Wisconsin Department of Transportation

Proposal #14: 1130-32-71, WISC 2018 011
Green Bay - Oconto
Lineville Road – Norfield Road
USH 41
Brown County

This is Addendum No. 01, which provides for the following:

ADDENDUM NO. 01

Addendum No. 01
ID 1130-32-71
Revised Sheet 44
December 5, 2017

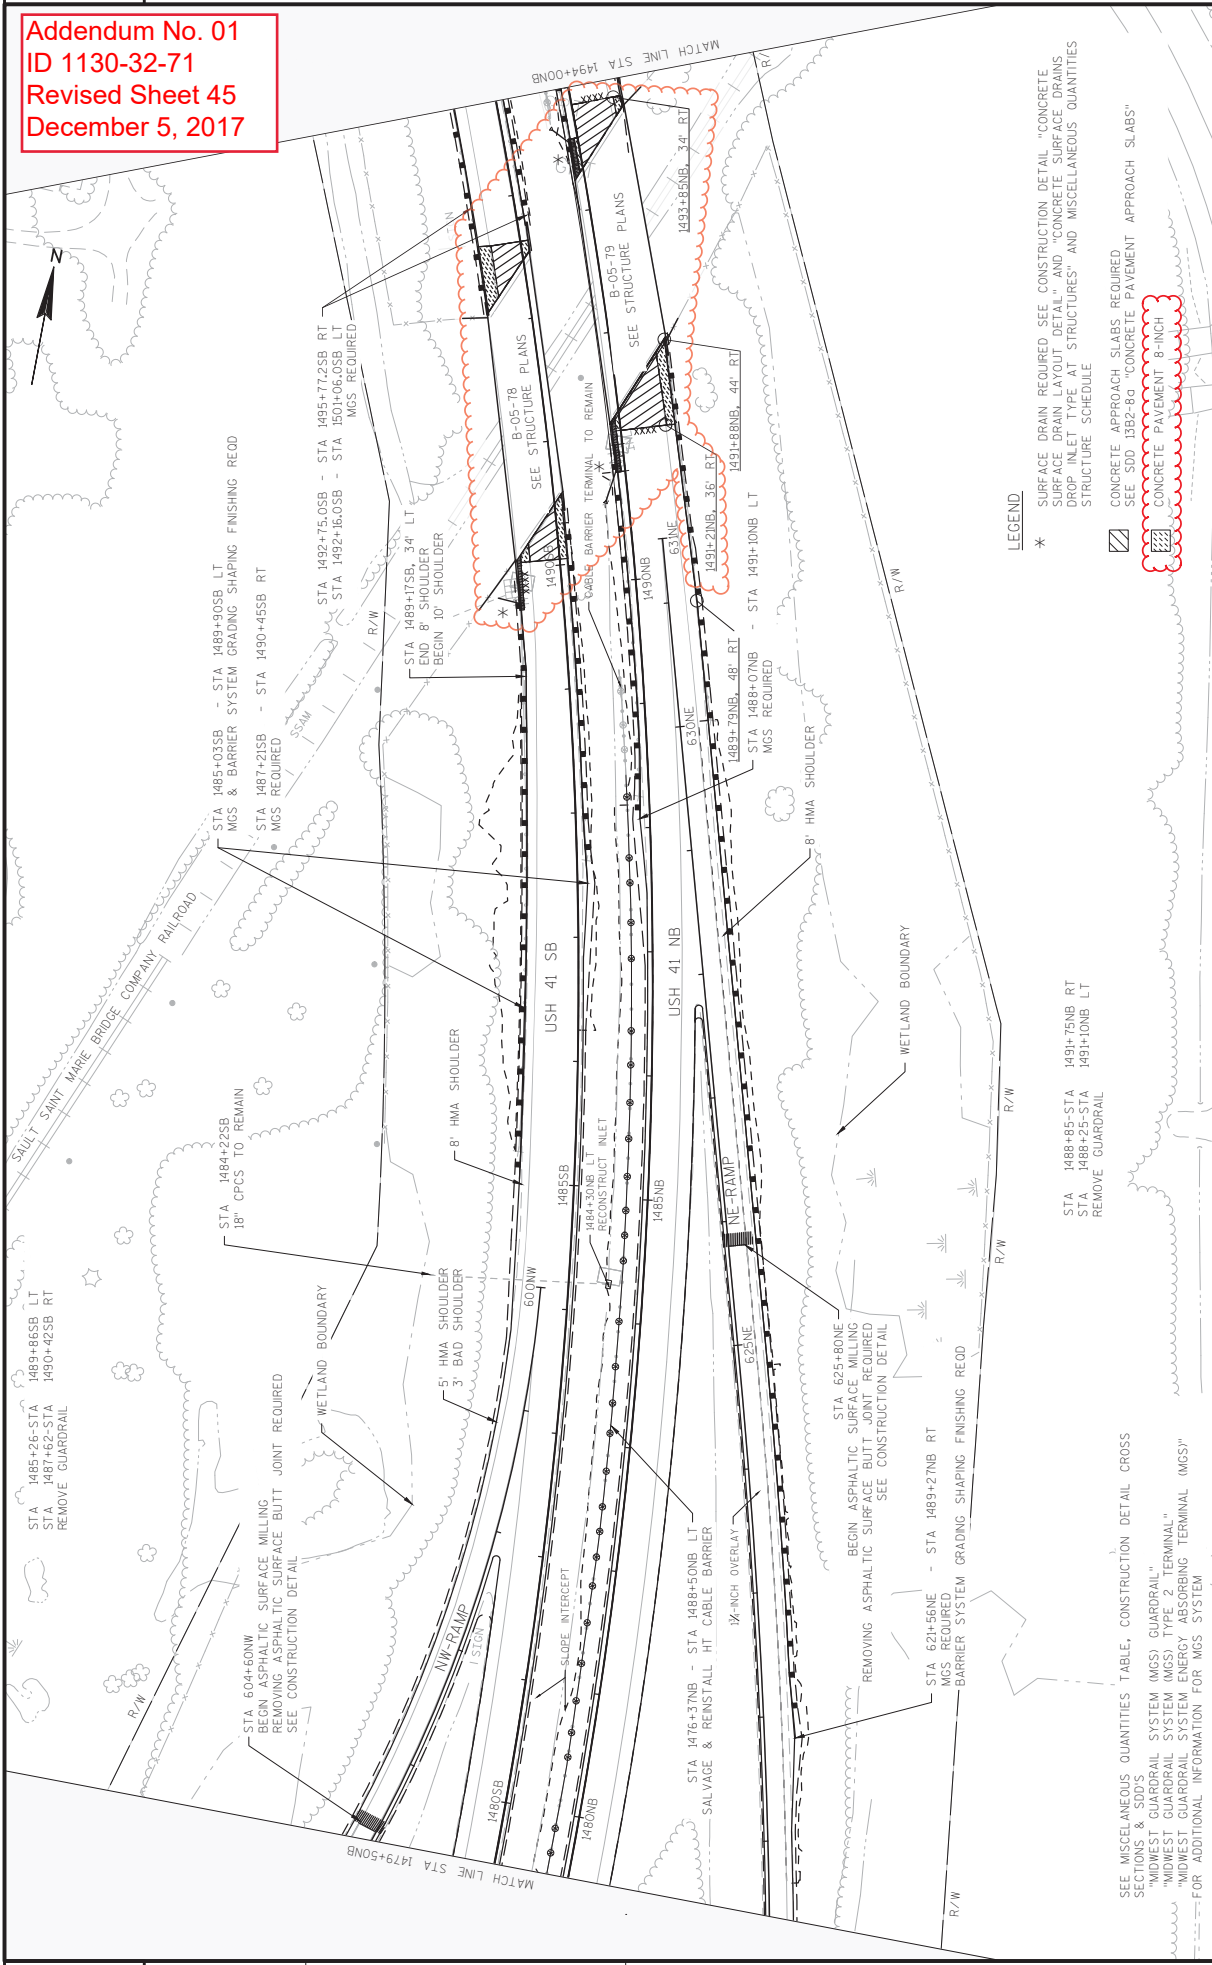
1130-32-71 & 1150-54-71 Plan sheets Revised Plan Sheets	
Sheet #	Plan Sheet Title (brief description of changes to sheet)
44	(USH 41 Plan Details) Revised and labeled 8-inch concrete & approach slab to match MQ
45	(USH 41 Plan Details) Revised and labeled 8-inch concrete & approach slab to match MQ
65	(Paving Grades) Corrected error in paving grade and show revised pipe location
71	(Erosion Control Plans) Moved storm sewer crossing pipe location
76	(Storm Sewer) Moved storm sewer crossing pipe location
90	(Lighting Plan) new lighting configuration to avoid railroad crossing
91	(Lighting Plan) new lighting configuration to avoid railroad crossing
92	(Lighting Plan) new lighting configuration to avoid railroad crossing
110	(Traffic Control: Advanced Warning Overview) Added lane split signing
215	(Traffic Control: NB Ramps Open at CTH B) Added signs for CTH B west closure
246	(Miscellaneous Quantities) Add in cold weather paving for stage 1 temporary pavement

Addendum No. 01
ID 1150-54-71
Added Sheet 219A
December 5, 2017

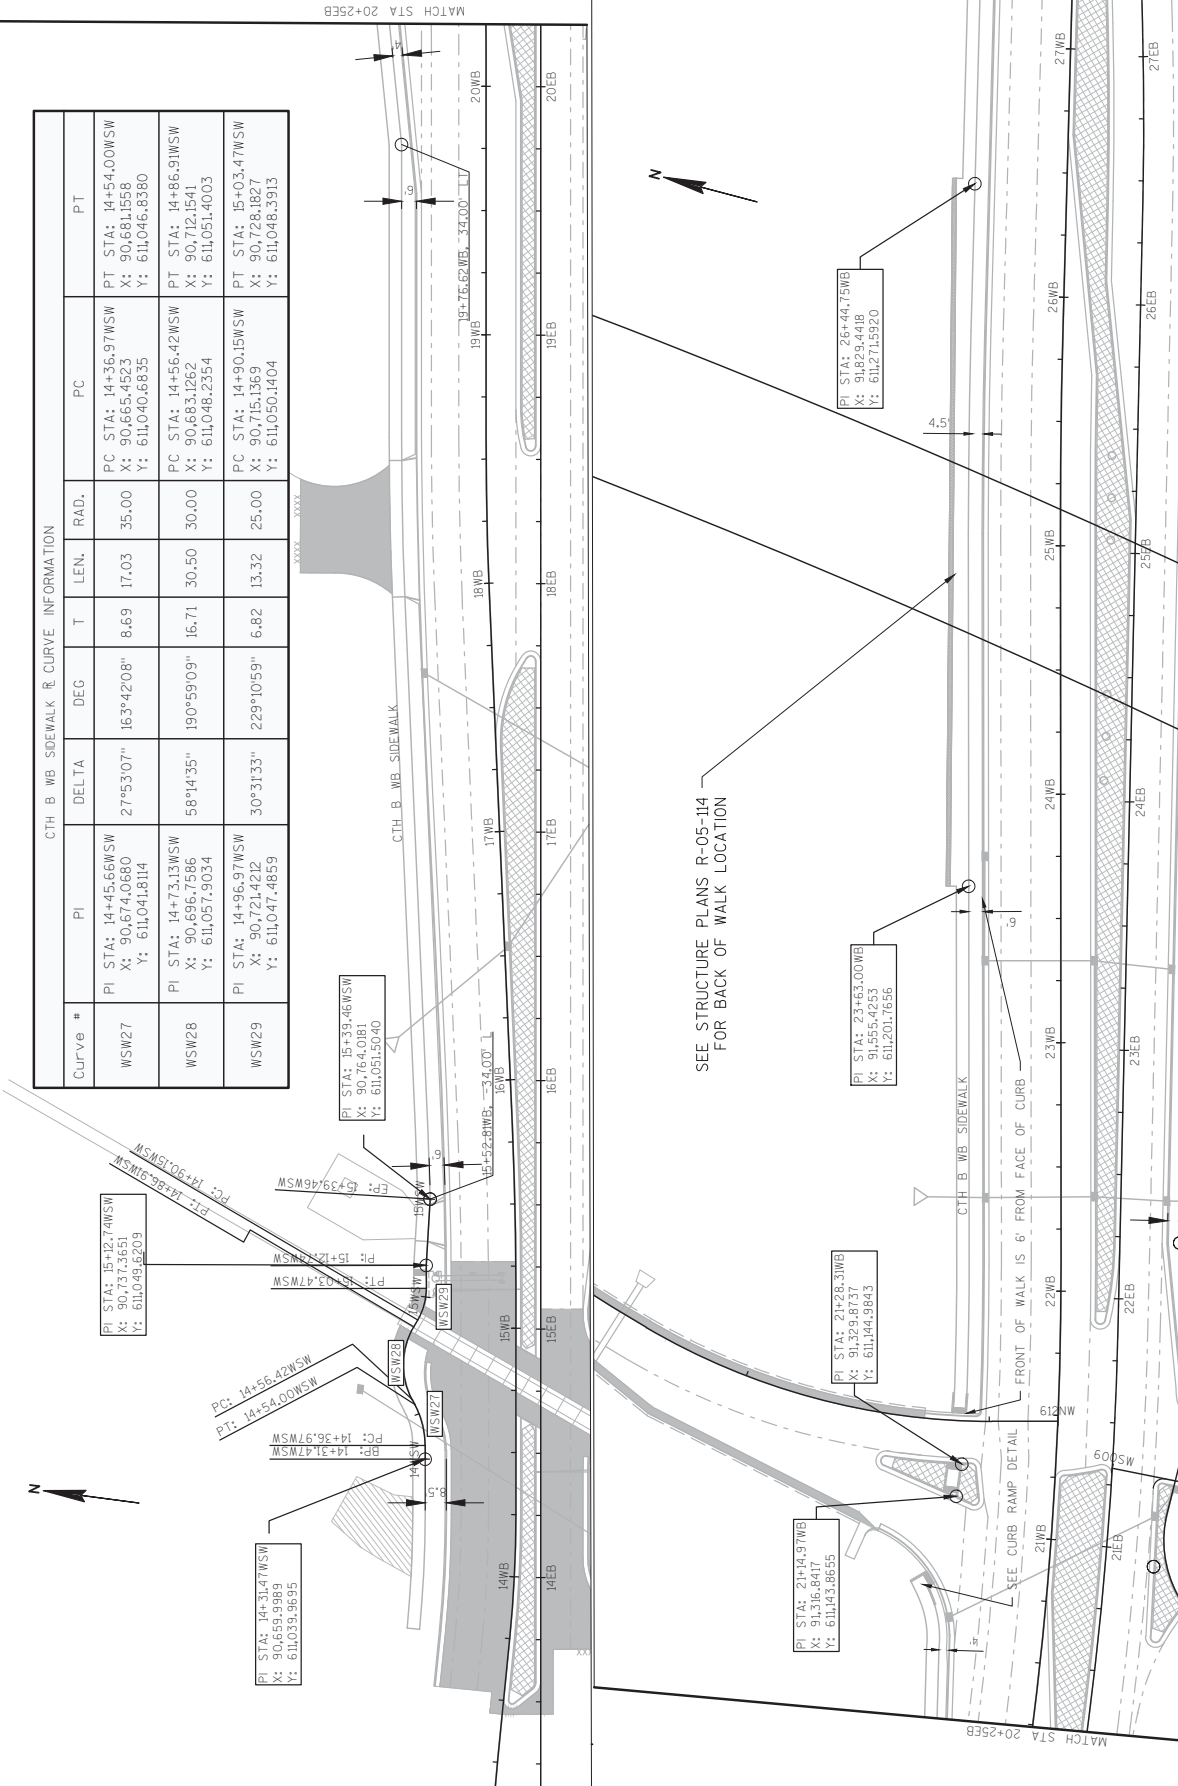
Added Plan Sheets	
Plan Sheet	Plan Sheet Title (brief description of why sheet was added)
1130-32-71 & 1150-54-71 Plan sheets	
219A	Alignment diagram: CTH B & West Deerfield Ave – sheet missing
219B	Alignment diagram: CTH B WB Sidewalk – sheet missing
219C	Alignment diagram: CTH B EB Sidewalk – sheet missing
456A	Temporary Signing – Missing sign detail for lane designation
456B	Temporary Signing – Added sign plate for USH 41 staged traffic
456C	Temporary Signing – Added sign plate for USH 41 staged traffic
456D	Temporary Signing – Added sign plate for USH 41 staged traffic
750A	Cross Sections: CTH B – Missing station 19+00'EB' for CTH B cross sections
766A	Cross Sections: SW-Ramp – Missing sections 600+50'SW' thru 601+00'SW'

Addendum No. 01
ID 1150-54-71
Revised Sheet 773
December 5, 2017

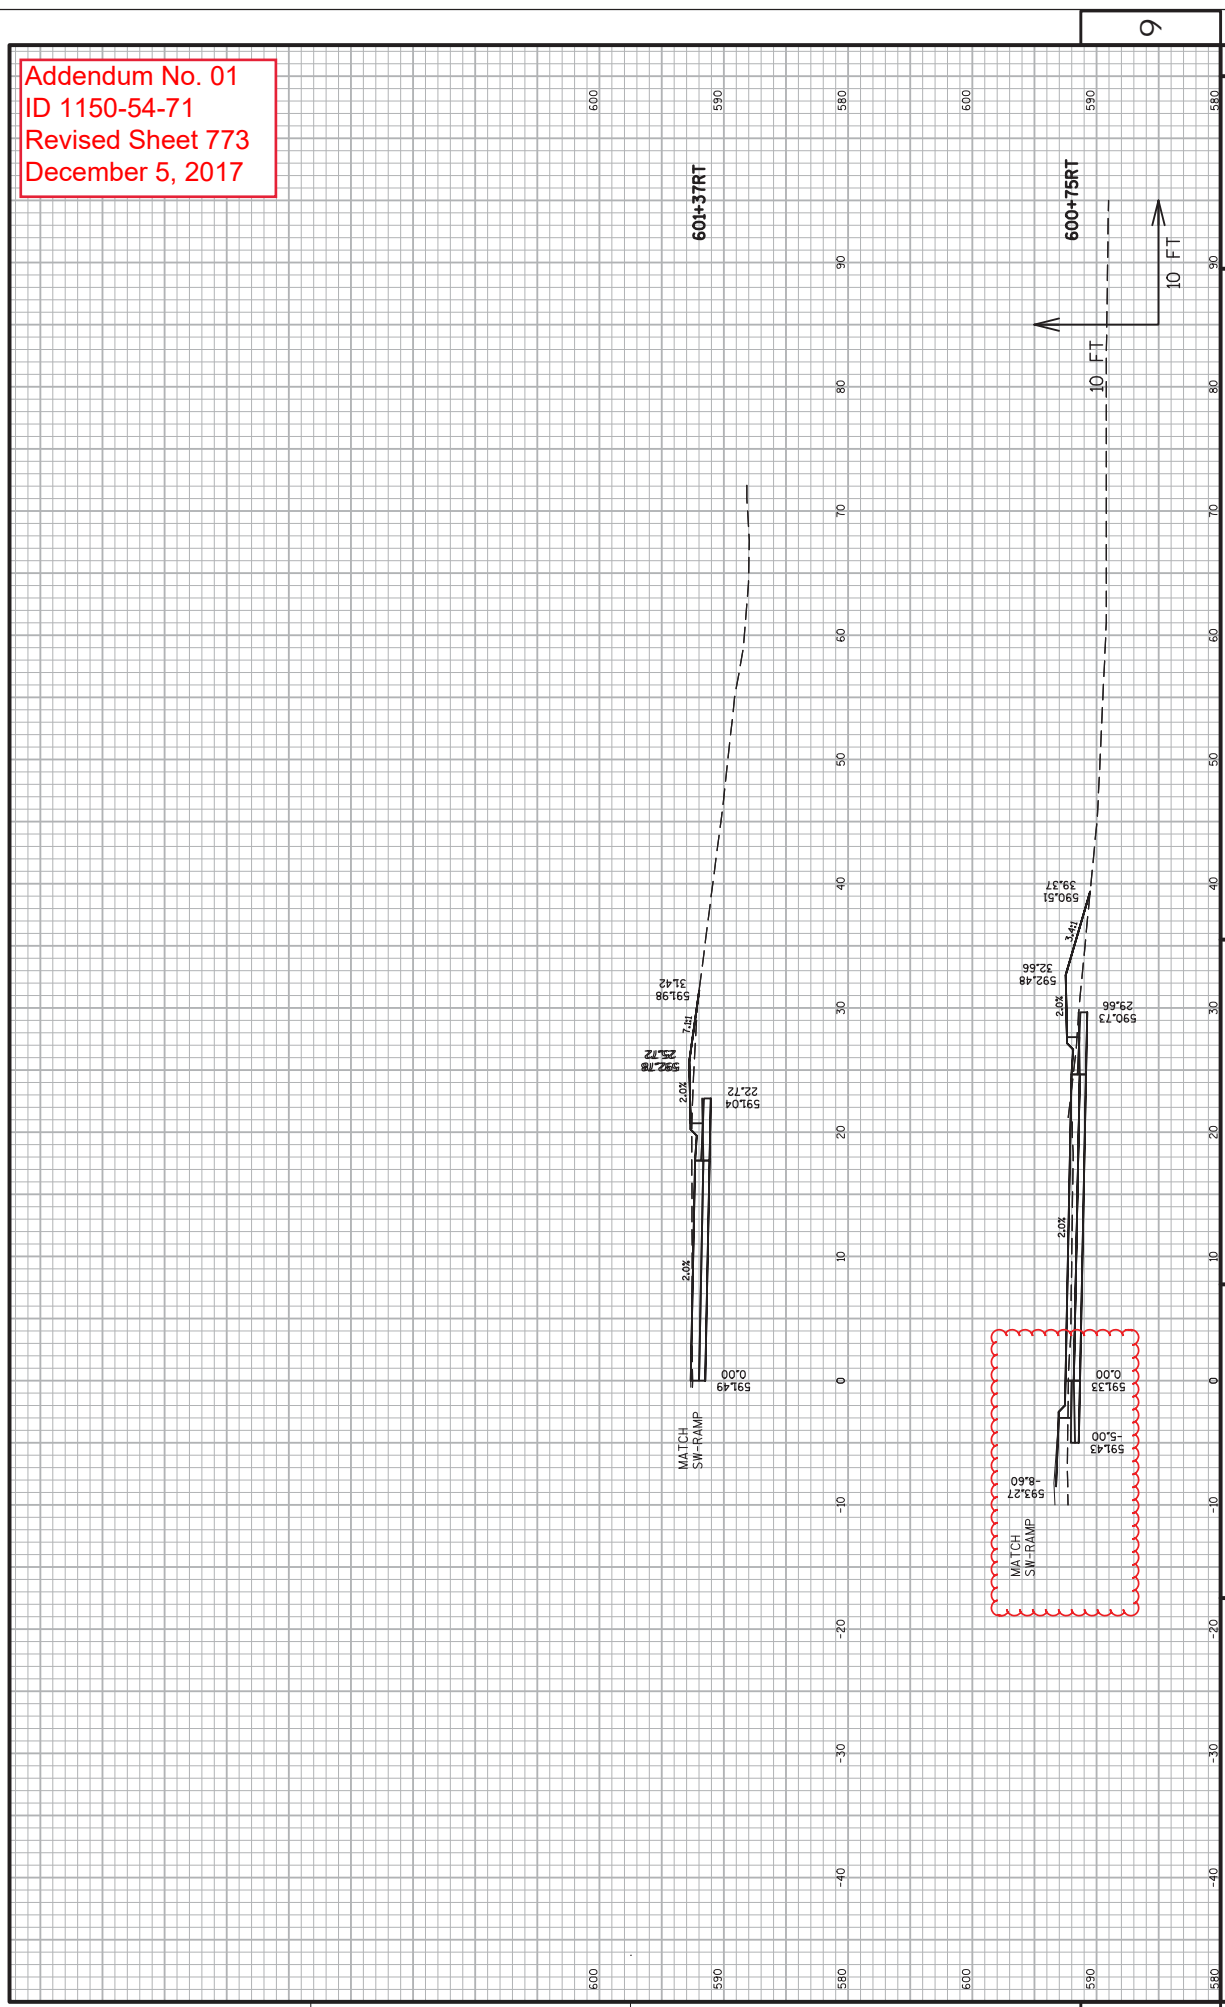
250	(Miscellaneous Quantities) Covering signs & fixed message quantity revised
268	(Miscellaneous Quantities) Change removal to abandon pipe
273	(Miscellaneous Quantities) Revised pipe location quantities
274	(Miscellaneous Quantities) Revised pipe location elevation & location
281	(Miscellaneous Quantities) Traffic Control Fixed message quantity revised
282	(Miscellaneous Quantities) Revised lighting configuration
298	(Plan & Profile: CTH B Eastbound) Revised pipe location, abandon pipe
301	(Plan & Profile: CTH B Westbound) Revised pipe location, abandon pipe
747	(Cross Sections: CTH B) Revised sections for pipe location
748	(Cross Sections: CTH B) Revised sections for pipe location & correct driveway note
770	(Cross Sections: CTH B) Correct subgrade slopes on right shoulder
773	(Cross Sections: RT-Line) Correct terrace slope on left median

Addendum No. 01
 ID 1150-68-71
 Revised Sheet 117
 December 5, 2017

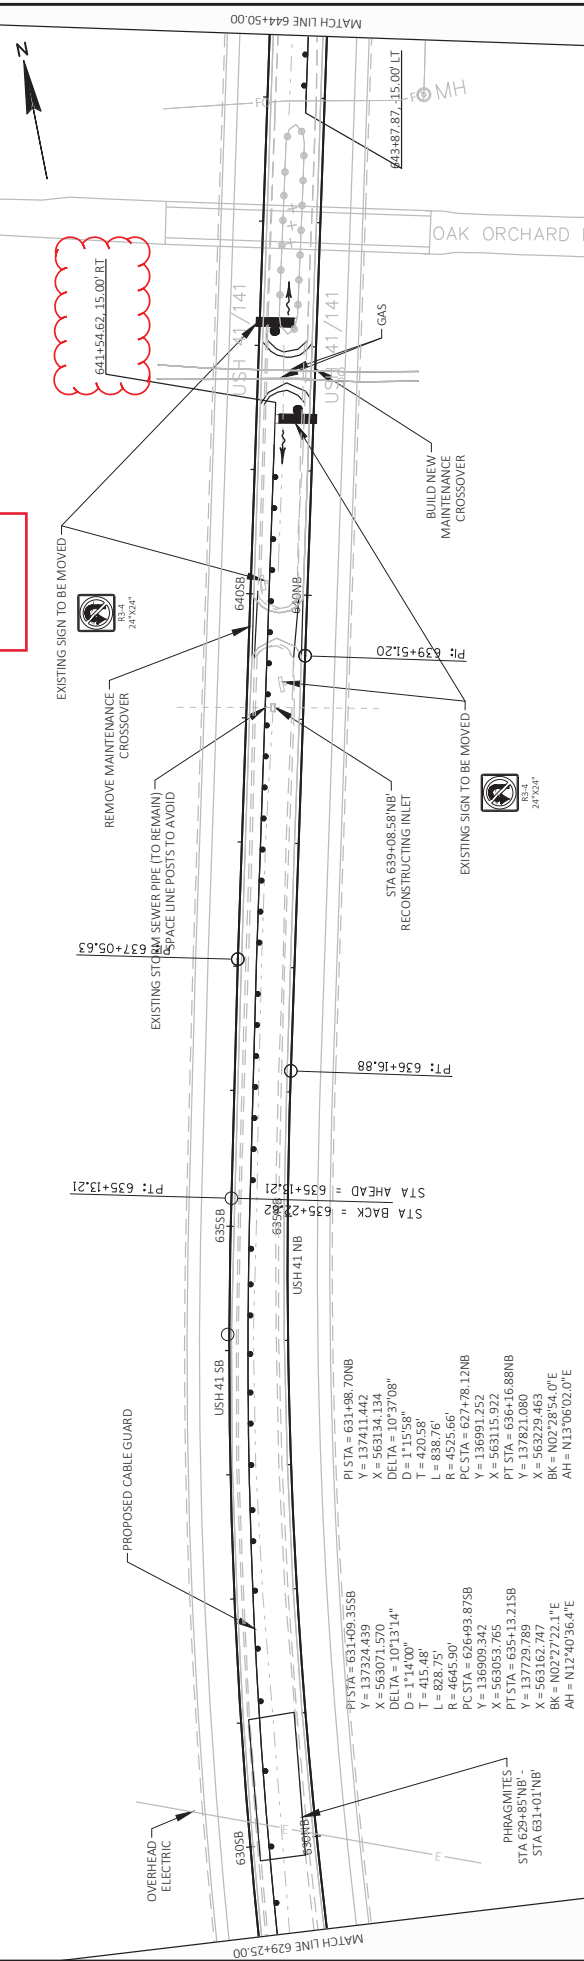
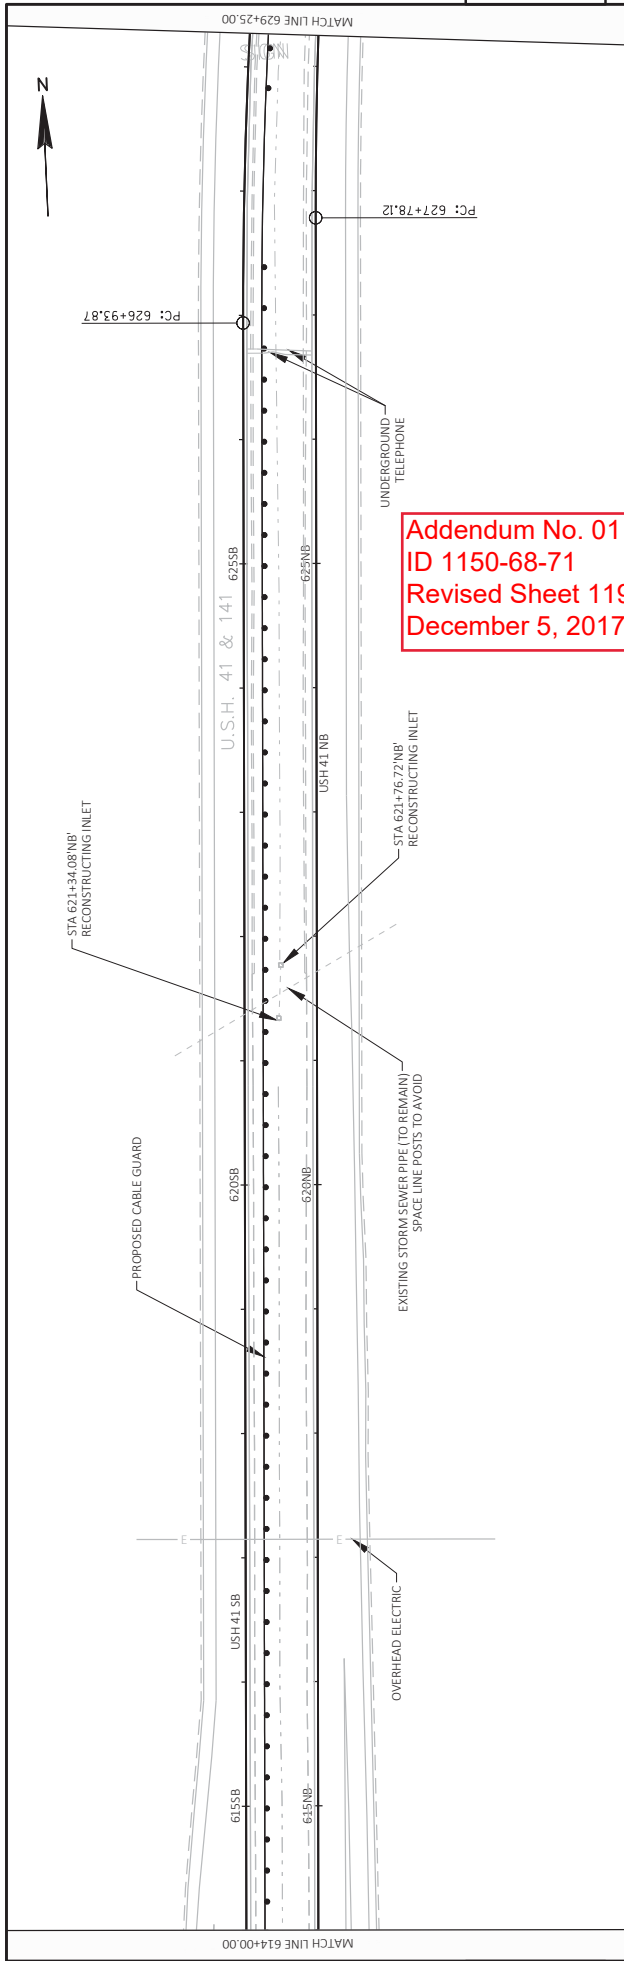
1150-68-71 Revised Plan Sheets	
Sheet #	Plan Sheet Title (brief description of changes to sheet)
92	Miscellaneous Quantities (revised stationing and quantity of Item 613.1100.S)
93	Miscellaneous Quantities (revised stationing and quantity of Item 613.1100.S)
99	Miscellaneous Quantities (revised quantities of Items 638.2102, 638.3000, and 634.0616)
108	Plan Sheet (change stationing for Proposed Cable Guard)
109	Plan Sheet (change stationing for Proposed Cable Guard)
110	Plan Sheet (change stationing for Proposed Cable Guard)
111	Plan Sheet (change stationing for Proposed Cable Guard & add moving signs callouts)
112	Plan Sheet (change stationing for Proposed Cable Guard)
113	Plan Sheet (change stationing for Proposed Cable Guard)
114	Plan Sheet (change stationing for Proposed Cable Guard & add moving signs callouts)
117	Plan Sheet (change stationing for Proposed Cable Guard & add moving signs callouts)
